COORDINATED DEVELOPMENT TILGHMAN HOLDINGS

MAJOR PLAN 2024-102

SUBJECT: COORDINATED DEVELOPMENT TILGHMAN HOLDINGS
MAJOR PLAN 2024-102
PRELIMINARY/FINAL PLAN REVIEW

SUBJECT: South Whitehall Township
Tilghman Holdings, LLC – Phase 1
Major Plan #2024-102
Preliminary/Final Plan Review

DESIGNED BY: X CHECKED BY: MFC DATE: 06-28-2024 SCALE: 1" = 40' JOB NUMBER: CW-23-119 SHEET: 2 OF 3

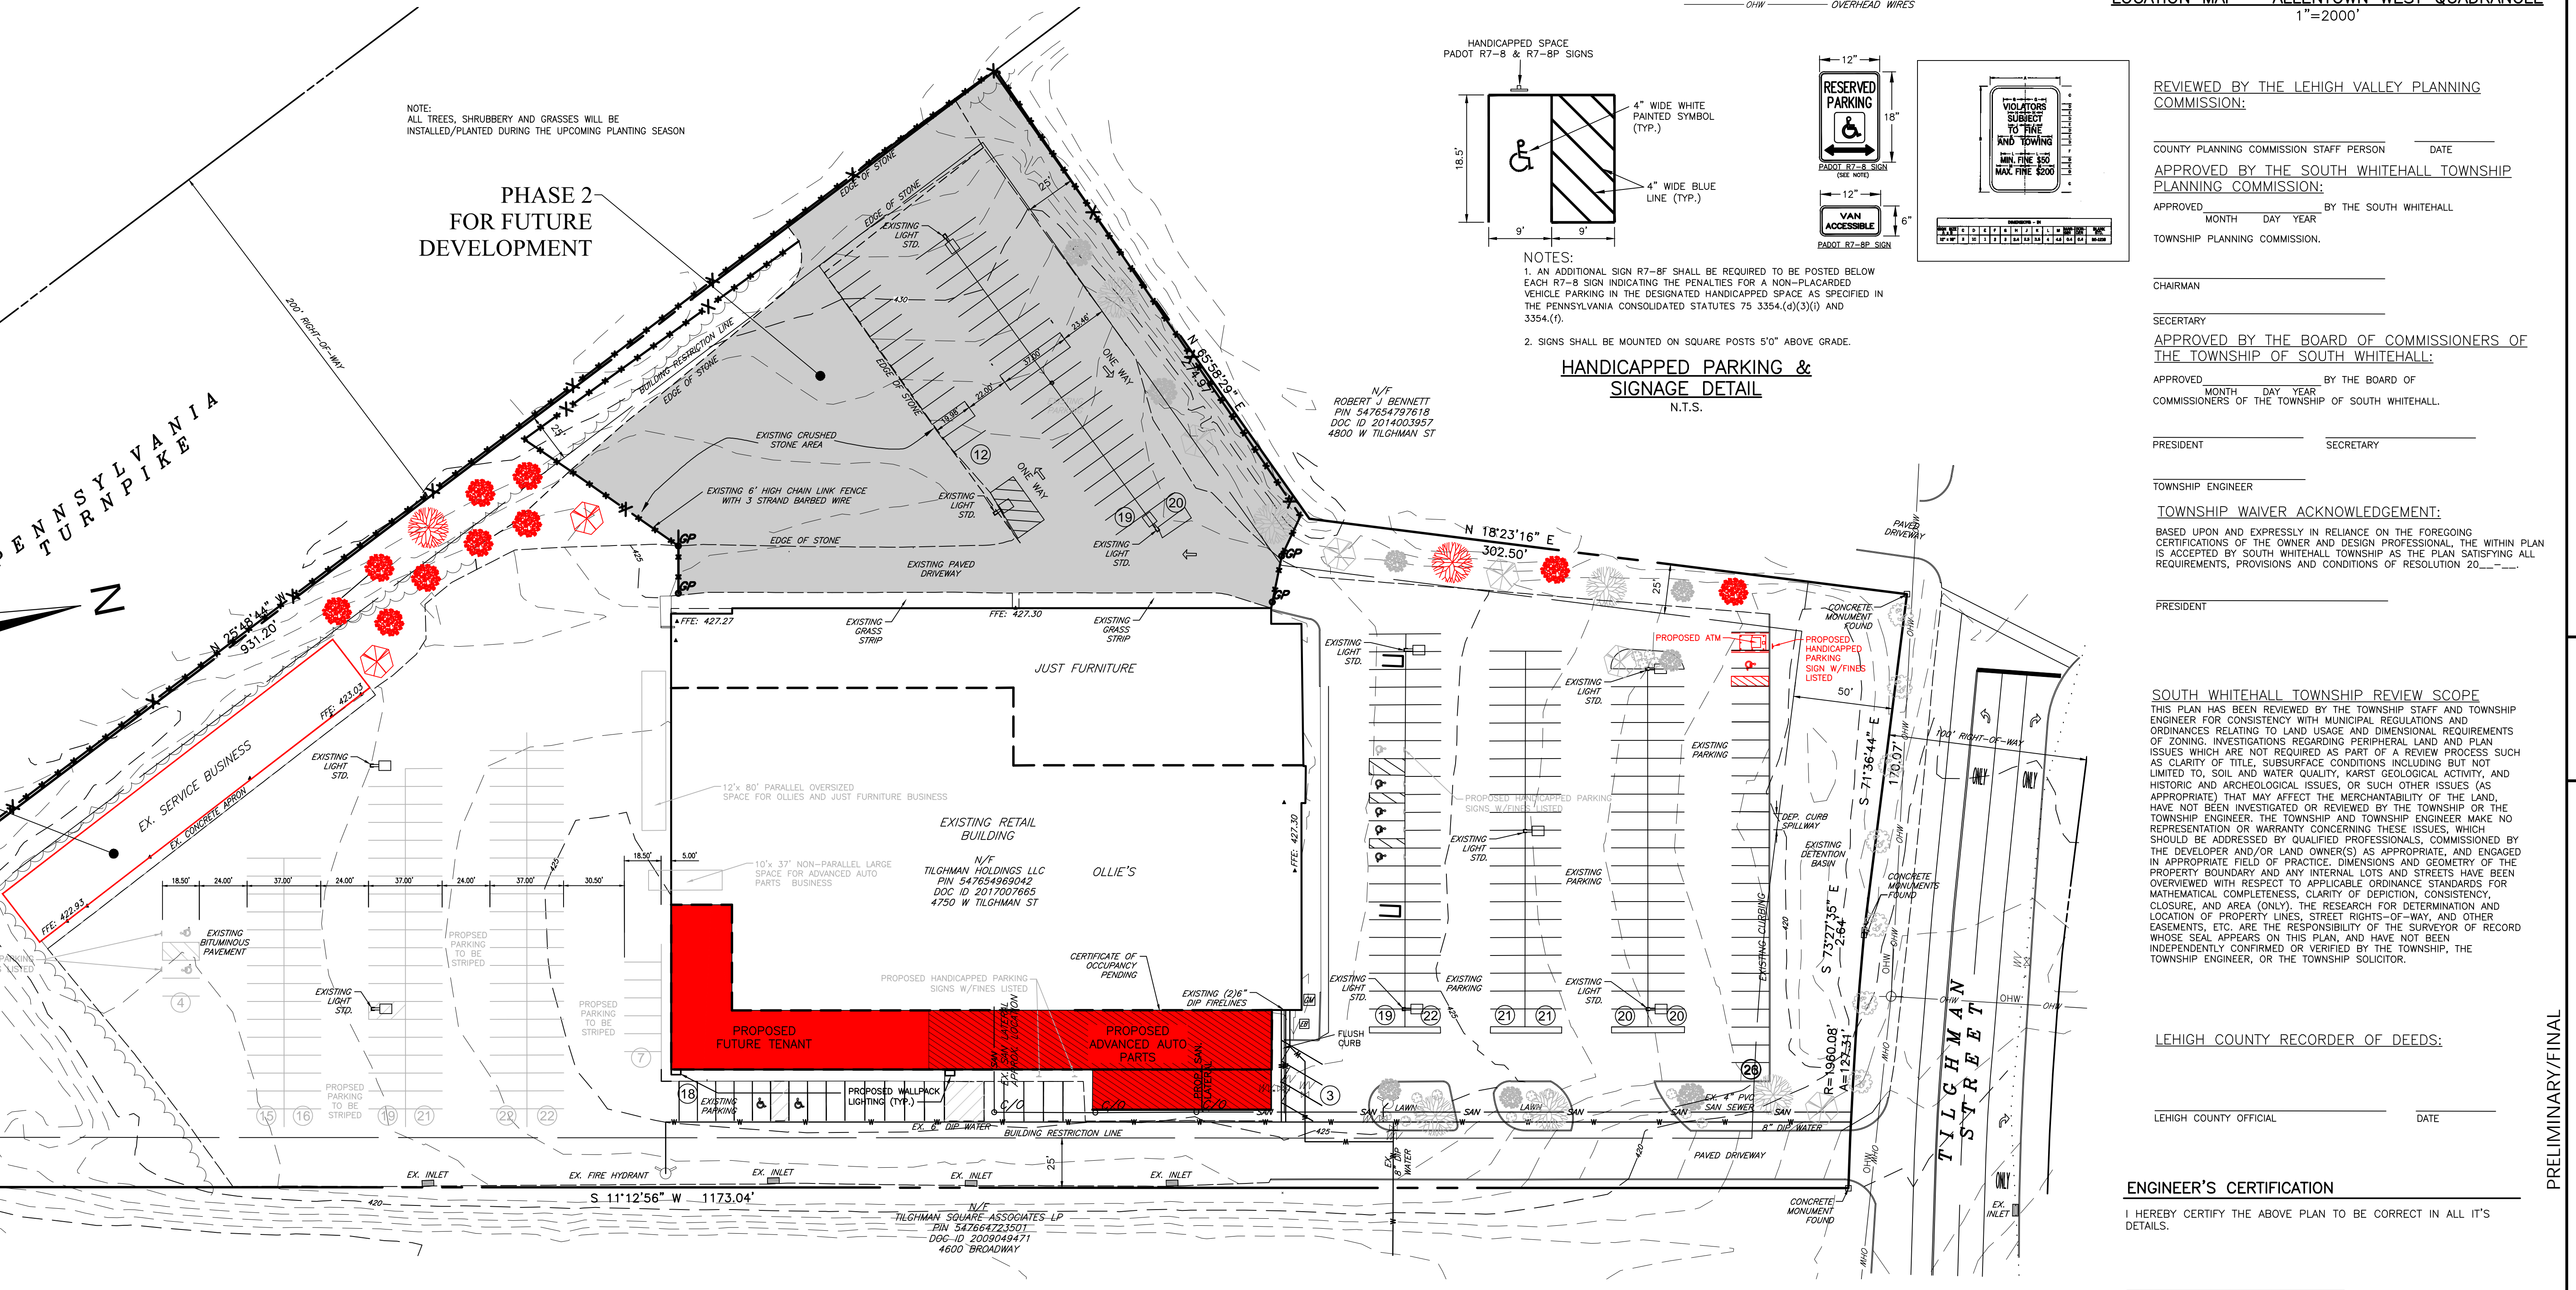
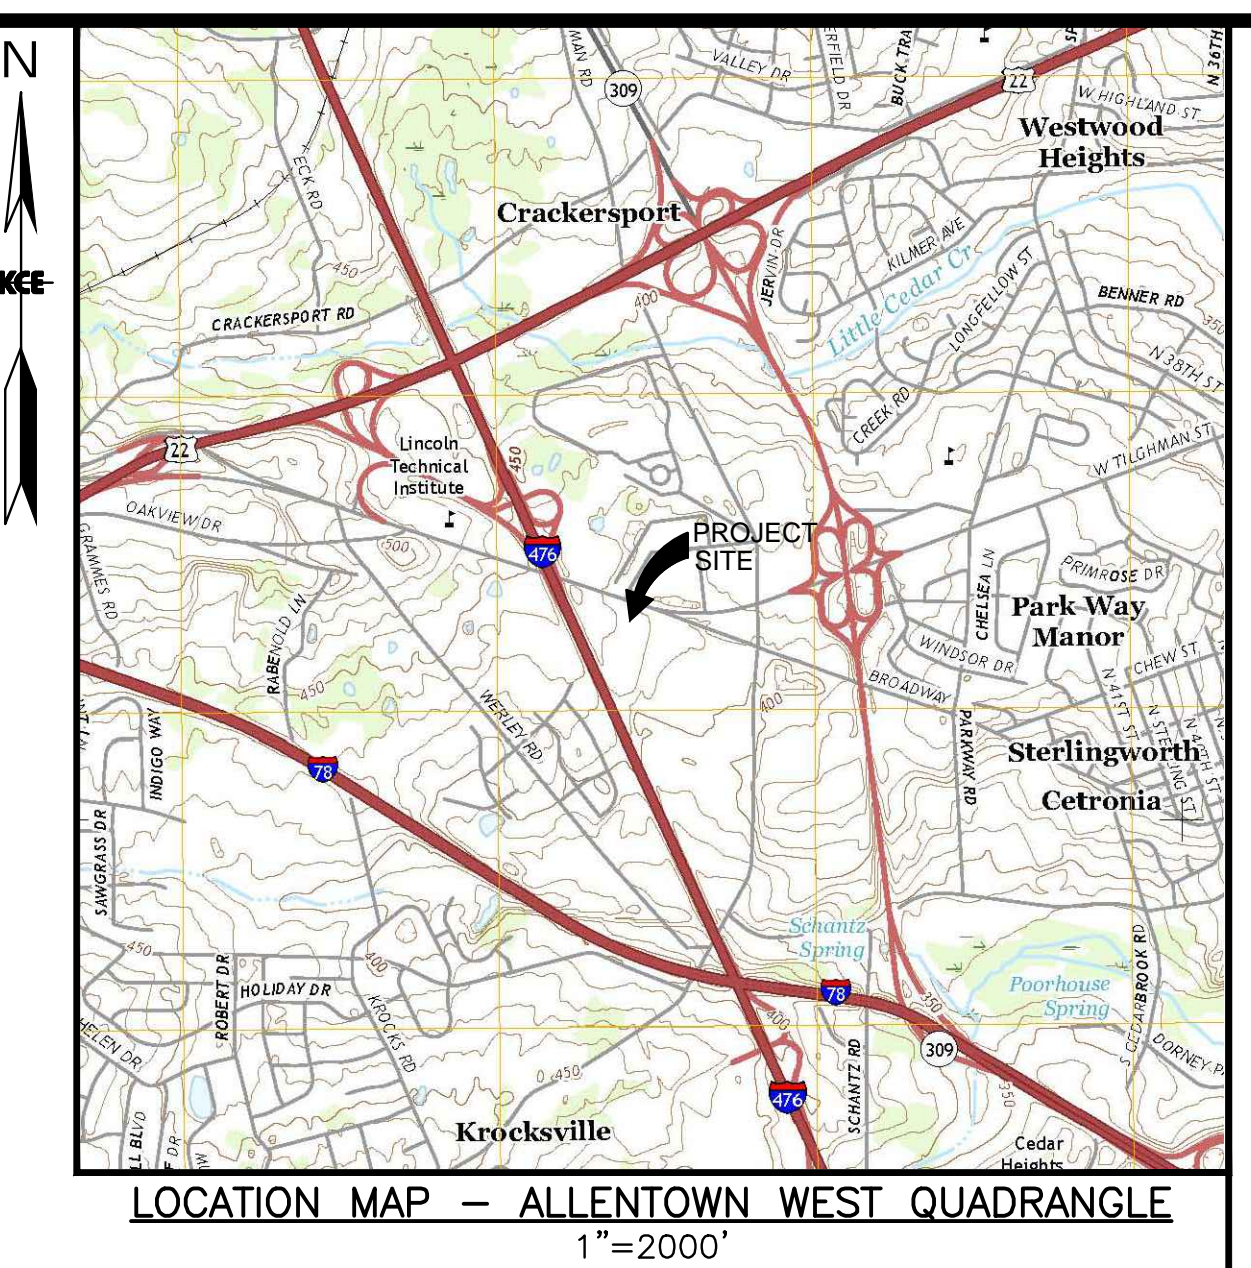
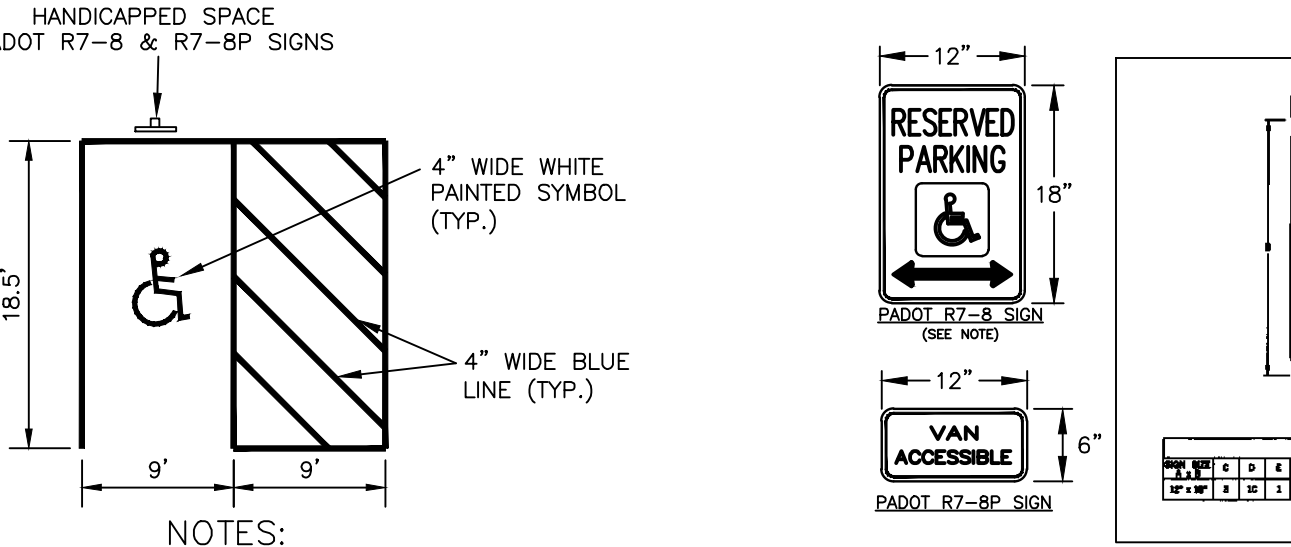
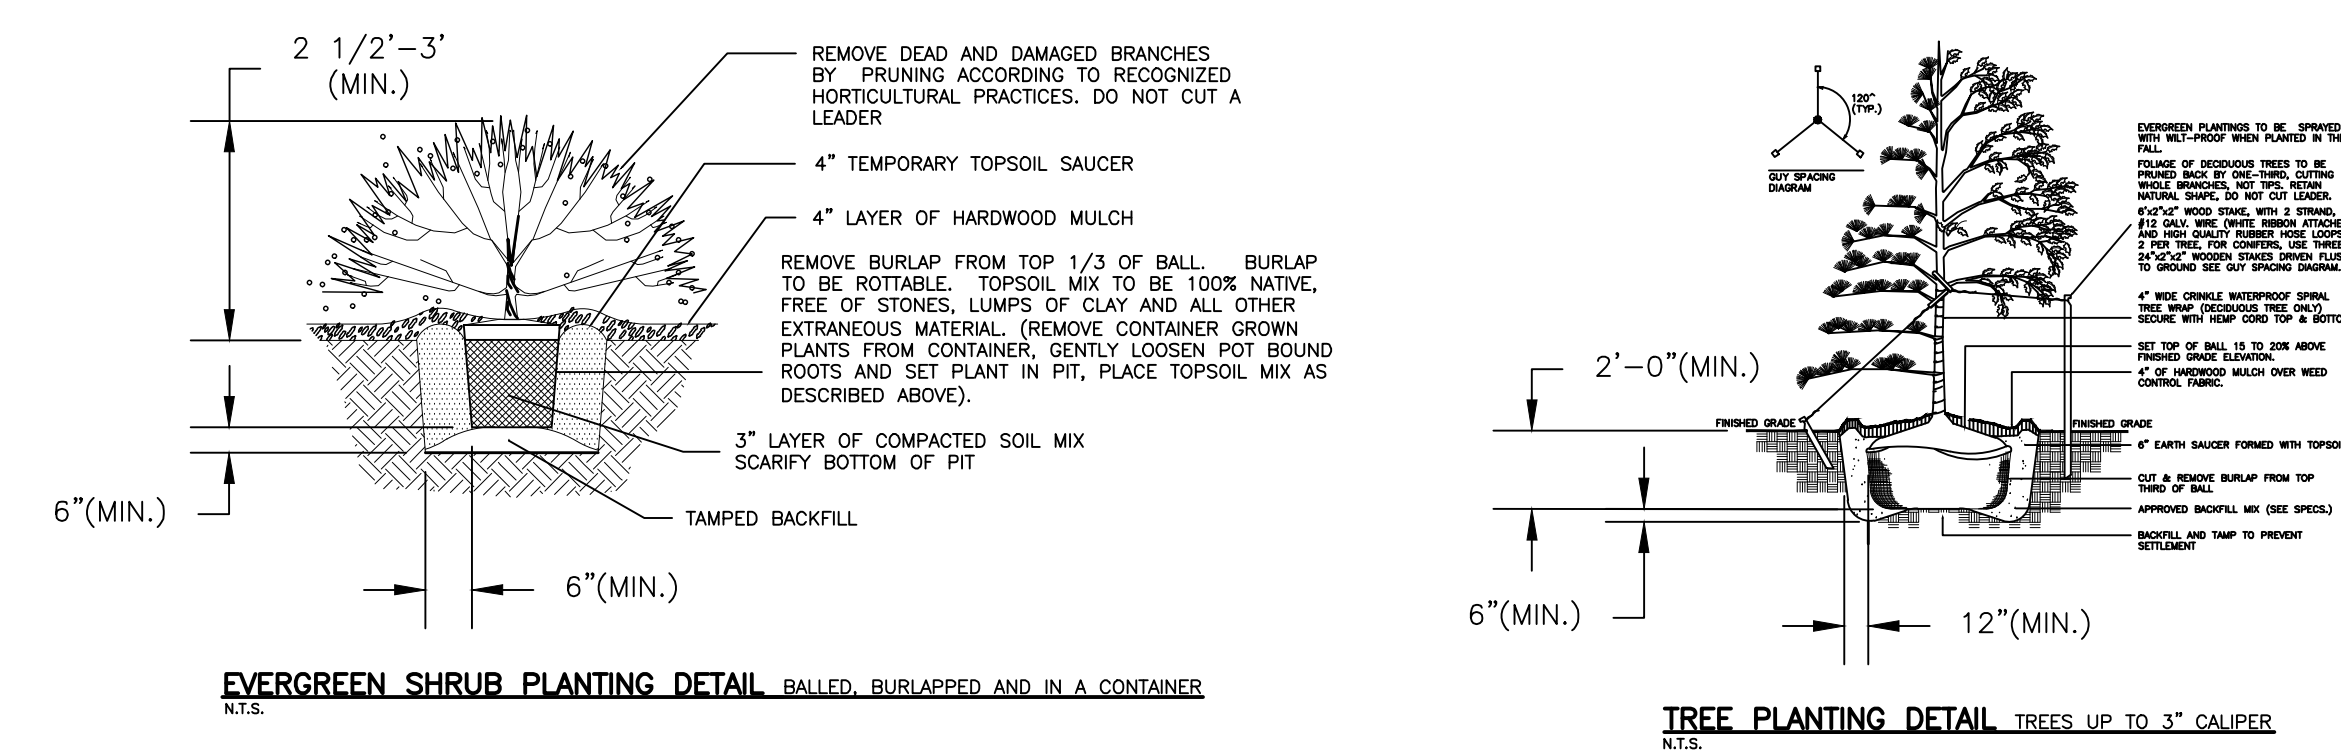
3. We defer the review and approval of the “Purpose of Plan” Statement to the Township Staff;
4. Check the total floor area of Ollies (42,697 sf) and Just Furniture (12,322) listed in the Parking Data (Phase 1) as the plan appears to show areas of 44,100± sf and 18,200± sf respectively. Further detail regarding these footprints should be provided and the Parking Data may need to be revised as necessary, SALDO §312-12(b)(8)(I);

7. Survey Notes 7 on Sheet 2 indicates that Plan has been prepared without benefit of a Title search and is therefore subject to any easements or other pertinent facts which such might disclose. The Township Solicitor should review the acceptability of this note;

1. Sheet 2 of 3: Please verify the domestic water line meter location and size.
2. Provide proposed water usage information for review and allocation calculations.
